UNITED STATES PATENT AND TRADEMARK OFFICE

APPLICATION NO.	FILING DATE	FIRST NAMED INVENTOR	ATTORNEY DOCKET NO.	CONFIRMATION NO.
10/721,657	11/25/2003	Siddhartha Panda	FIS920030133US1 (175P012)	7420
28264 7590 02/18/2009 BOND, SCHOENECK & KING, PLLC ONE LINCOLN CENTER SYRACUSE, NY 13202-1355			EXAMINER VINH, LAN	
			ART UNIT 1792	PAPER NUMBER
			NOTIFICATION DATE 02/18/2009	DELIVERY MODE ELECTRONIC

Office Action Summary	Application No. 10/721,657	Applicant(s) PANDA ET AL.	
	Examiner LAN VINH	Art Unit 1792

DETAILED ACTION

FIG. 5

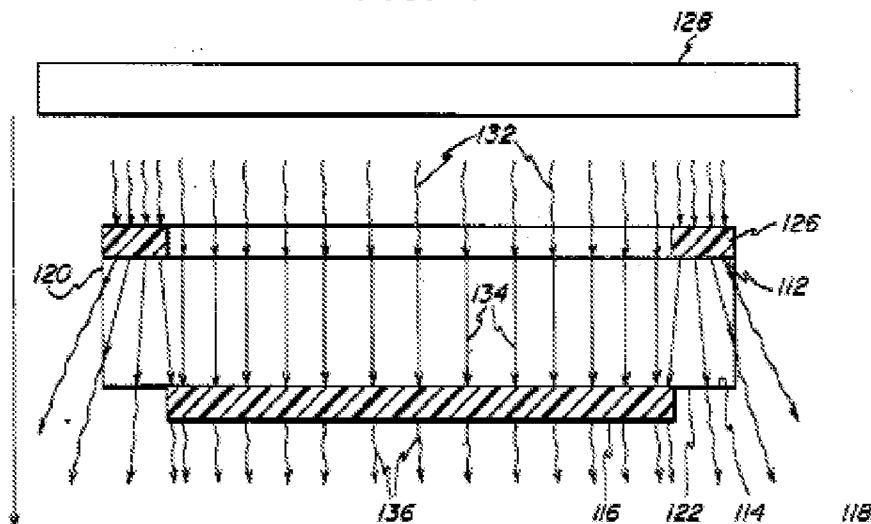
It is argued that fig. 5 of Anthony discloses only a single region comprising a single material, and it does not include "a second region comprising a material." as required by amended claim 11. This argument is unpersuasive because the structure 110 of Anthony shows a first region 126/comprising a material having a first non-zero transmittance and a second/central region of structure 110 comprising a material_having second non-zero transmittance

Anthony discloses a body/structure 110/a filter, the structure comprise the perimeter region 126(eccentric shaped)/first region comprising a material having a first non-zero transmittance with respect to infrared wavelength(s) 132 emitted from radiation source 128 (IR lamp), a center portion of body 110 (eccentric shaped)/second region comprising a material having second non-zero transmittance with respect to infrared

Anthony discloses a semiconductor element embodying an optical coating comprises a front surface of guard ring 126/first surface adapted to receive and transmit infrared radiation having wavelength(s) 132 emitted from radiation source 128 (col 7, lines 3-60; fig. 5)

infrared radiation through said first surface, with the filtering structure being characterized by a plurality of transmission regions (perimeter and center regions), with said transmission regions of said plurality of transmission regions being characterized by an aluminum alloy/metallic coating 116 having different respective thicknesses and varying degrees of transmittance varying degrees of transmittance (more radiation 132 are passed through the center portion/region of the structure 110) with respect to the infrared wavelength(s) (col 5, lines 30-35, col 8, lines 60-65; col 10, lines 65-68; fig. 5), and with said transmission regions of said plurality of transmission regions being distributed over said area
